From: Skripnikova, Galina
Sent: Wed Apr 14 21:08:39 2010
To: Lacy, Stuart C (QO Inc.); McAughan, Kelly; Bodek, Robert; Bondurant, Charles H
Cc: Ritchie, Bryan
Subject: RE: Rotary Sidewall
Importance: Normal
Attachments: Macondo_TD_Section_SWC.ppt

From: McAughan, Kelly
Sent: Wednesday, April 14, 2010 10:12 AM
To: Bodek, Robert; Lacy, Stuart C (QO Inc.); Skripnikova, Galina
Cc: Bondurant, Charles H; Ritchie, Bryan
Subject: Rotary Sidewall

**Rt scanner dip-interpretation
X-bedding?**

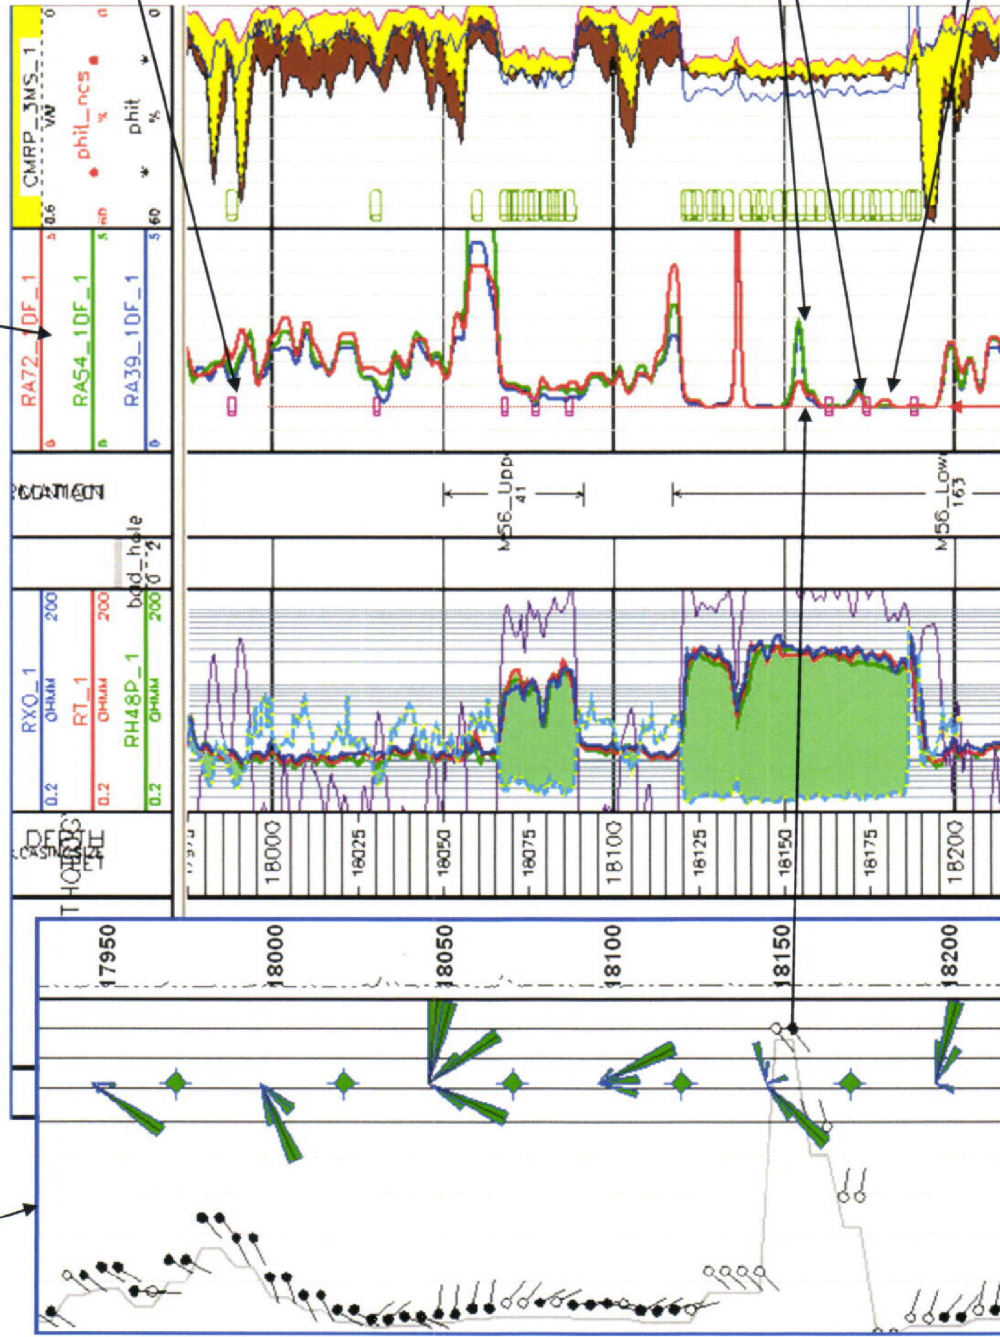
Resistivity anisotropy curves (Rv/Rh) – for 3 diff DOI resistivity curves
If it's > 1 – anisotropy. Thin lamination of shale and sands
or thin lamination of different quality rocks which could not be resolved with
conventional logs.

The magenta markers:
Currently
recovered samples,
need to confirm second
run recovery with
Stuart

Look at the
sand only:

1) Upper lobe is
more
heterogeneous
than lower in
general more
than 3 samples
needed

2) These 3 are
looking like
cross bedding:
Stuart, please
see if possible
to adjust to the
program
samples at
18,154' md
18,171' md
And maybe
18,179' md
